INC. VILLAGE OF FREEPORT

October 2, 2023
AMENDED LETTER OF DENIAL

RE: 65 Porterfield Pl. Freeport, NY
Zoning District – Res. A Sec. 54, Blk. 92, Lot 19
Building Permit Application #20212493
Description– Maintain existing accessory awning (513sq.ft)

PROPERTY INFORMATION, GENERAL NOTES AND PLOT PLAN

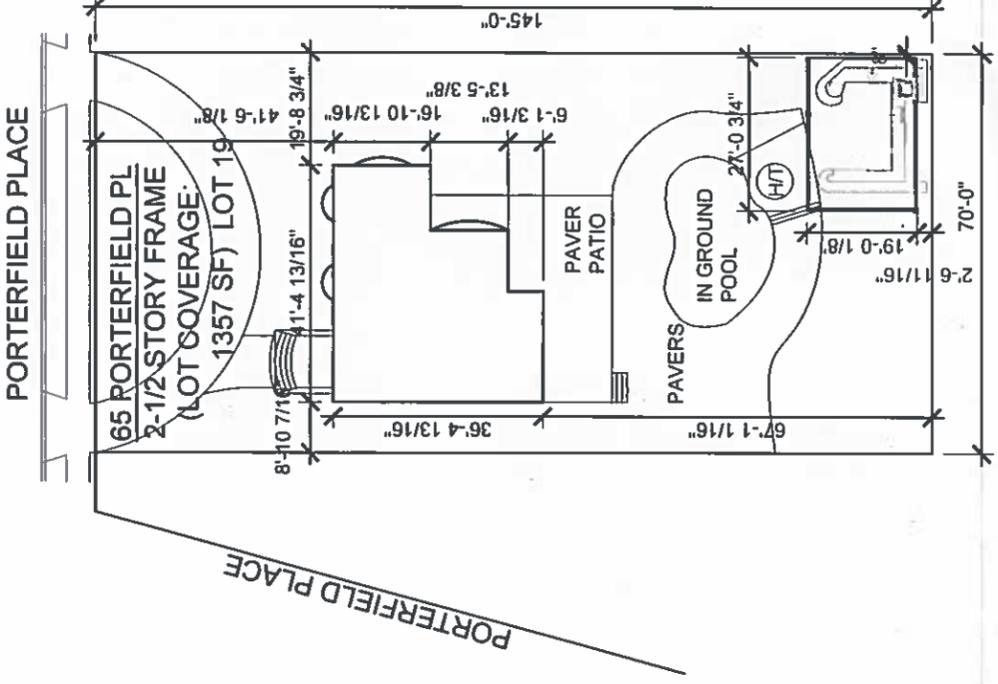
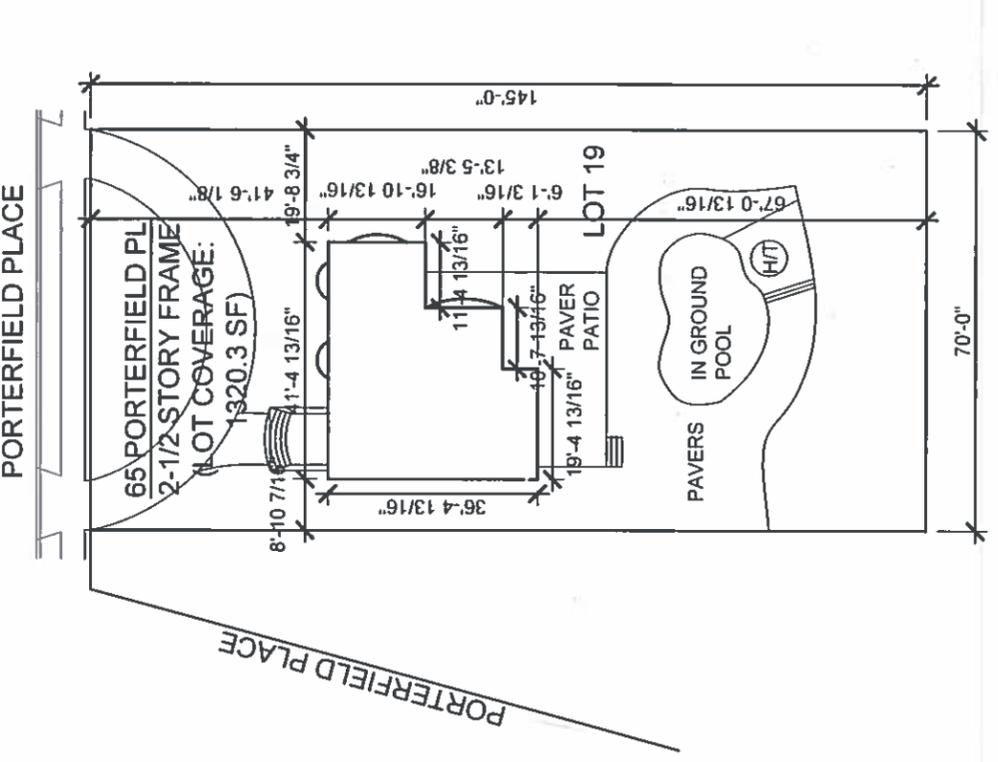
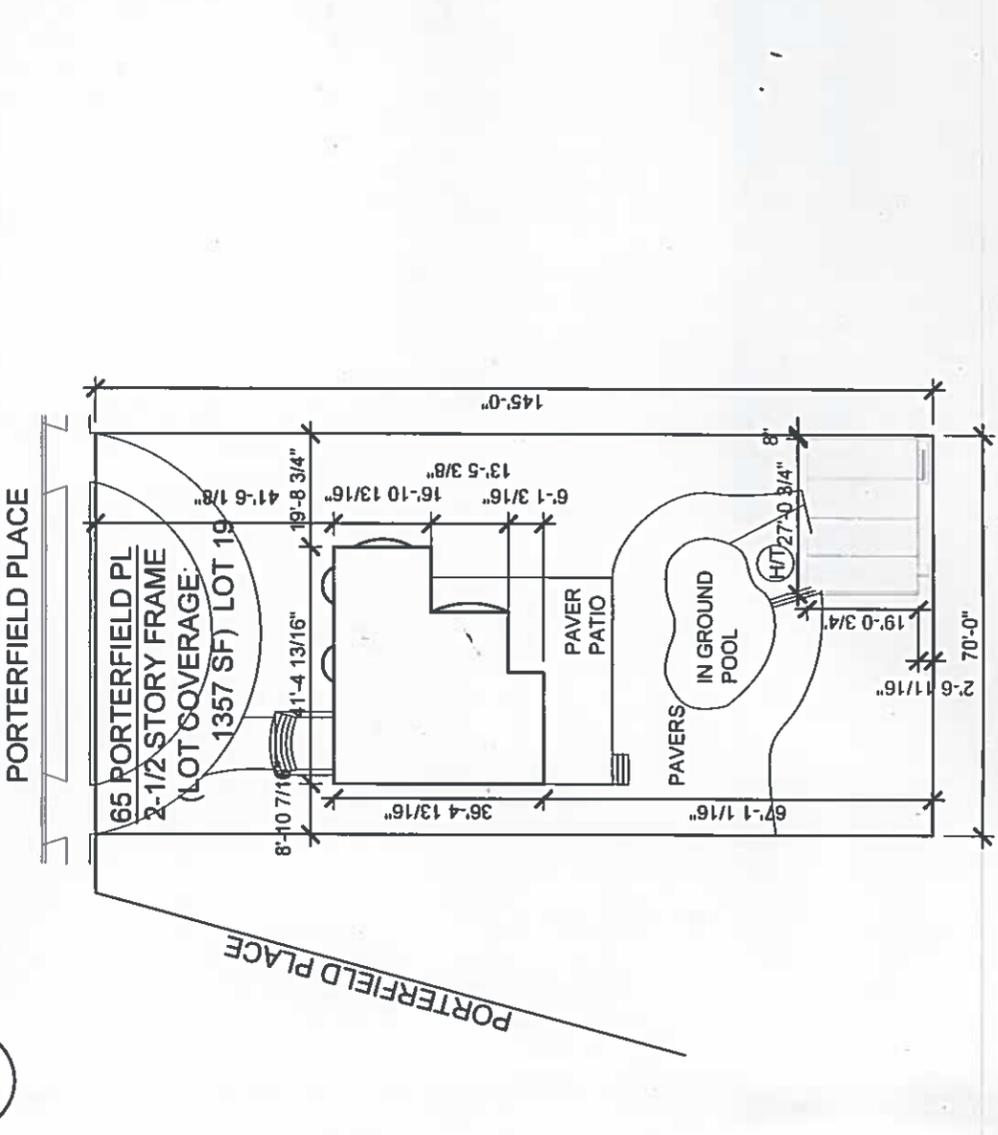
(2) Rear yard depth: minimum five feet, except for lots which abut canals or navigable waters, a minimum depth of 20 feet measured landwards of the average line of the bulkhead shall be provided; if no bulkhead exists, measured 20 feet landwards of the rear property line. According to the plans that you have submitted indicates that you have a 2'6" rear setback.

(3) Side yards width: No accessory building, accessory structure, barbecue pit, detached garage or breezeway shall be erected in any side yard. According to the plans that you have submitted indicates that you have 8" side setback.

DRAWING TITLE:
EXISTING SITE PLAN & GENERAL NOTES

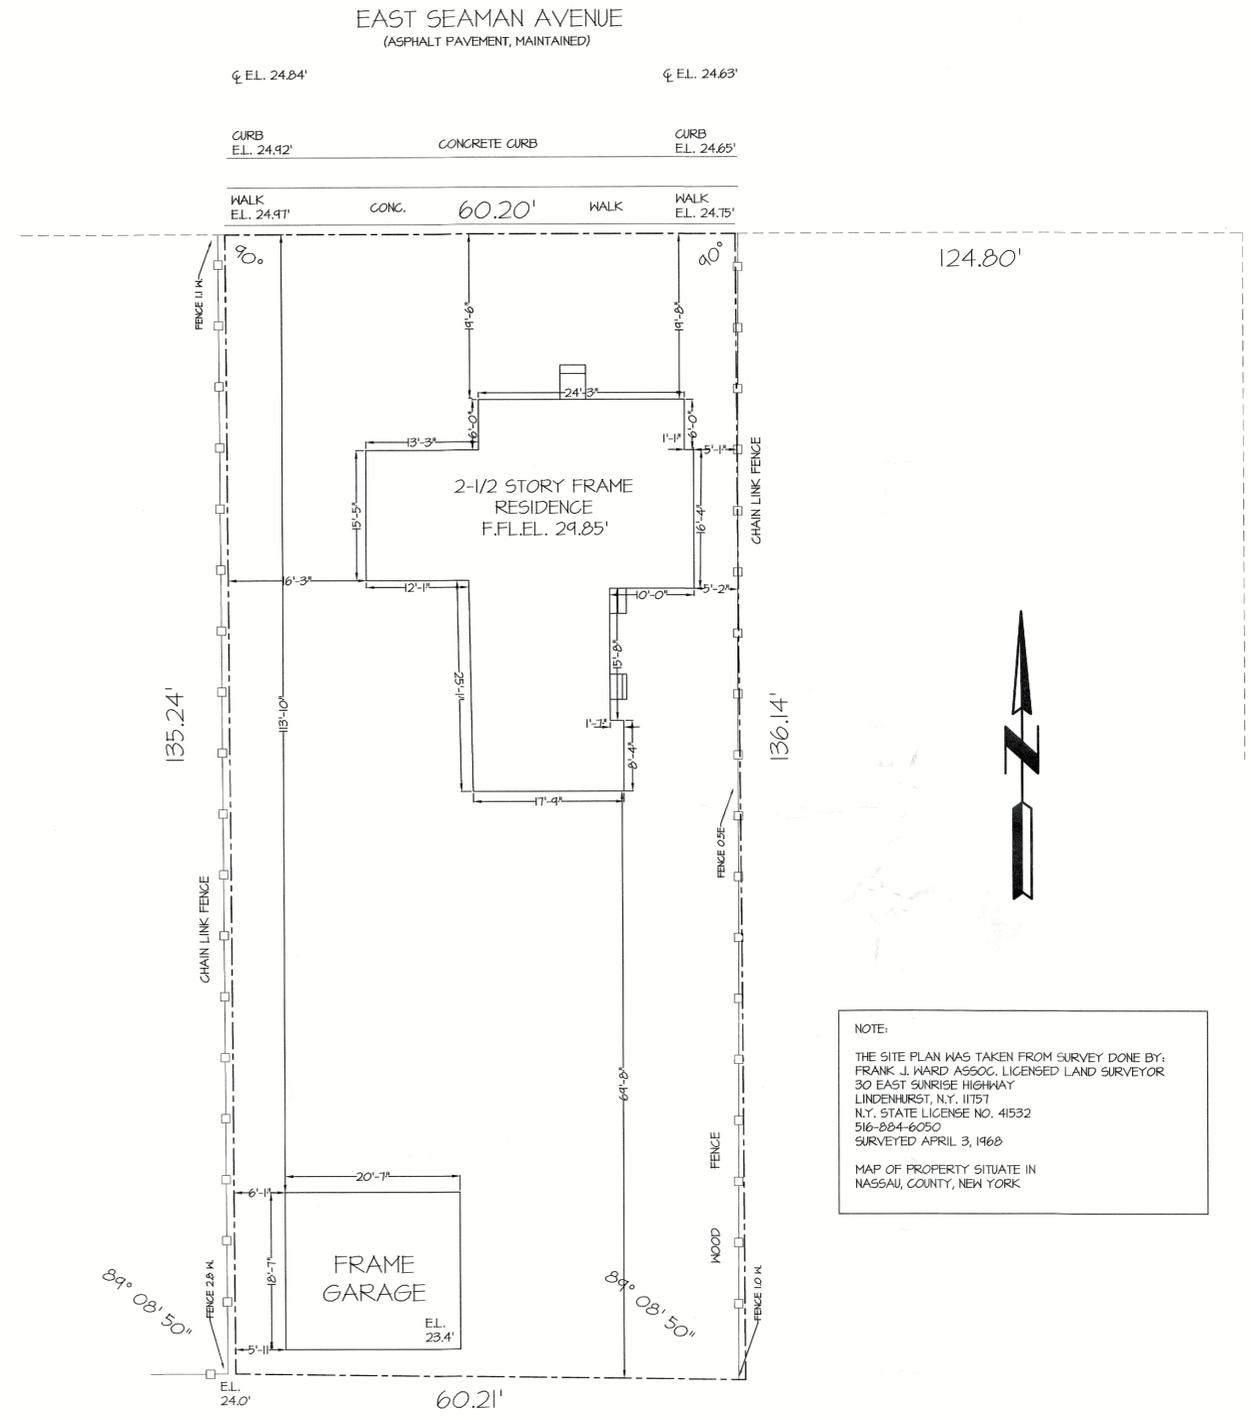
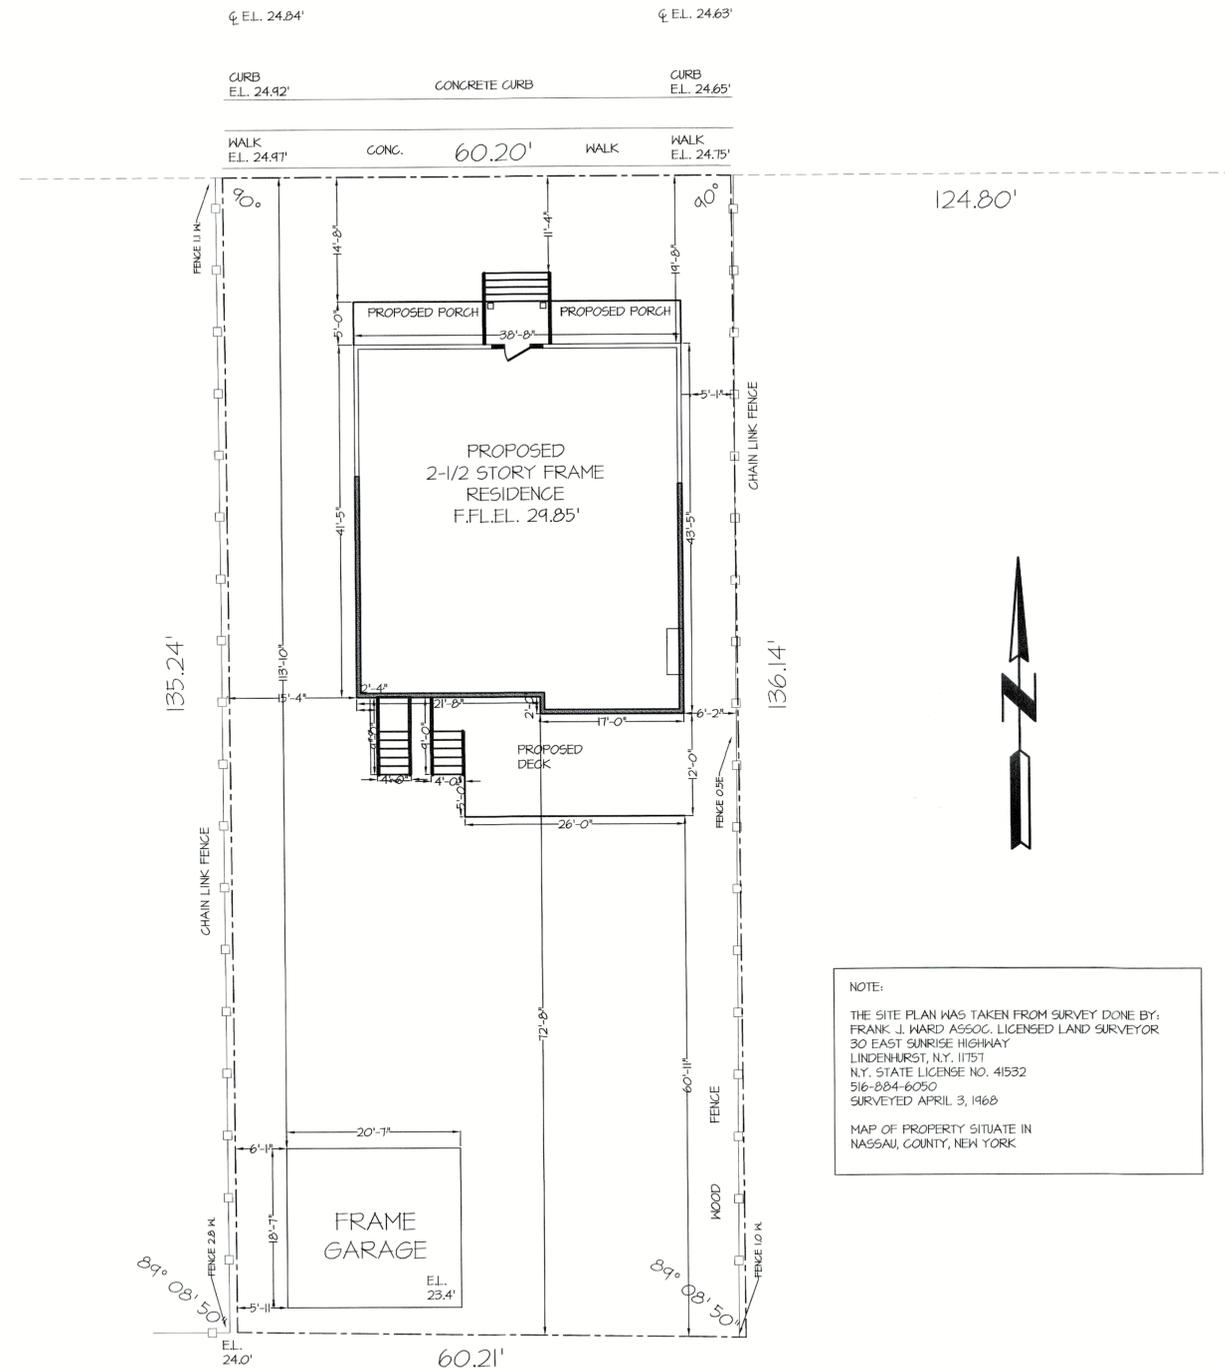
(1) Front yard depth: minimum 20 feet or the average depth of all residential front yards on the same side of the street within two hundred 200 feet in either direction, whichever is greater, but in no case more than 40 feet. According to the plans that you have submitted indicates that you have a front setbacks of 14'-8". You will be seeking a variance of 5'-2"
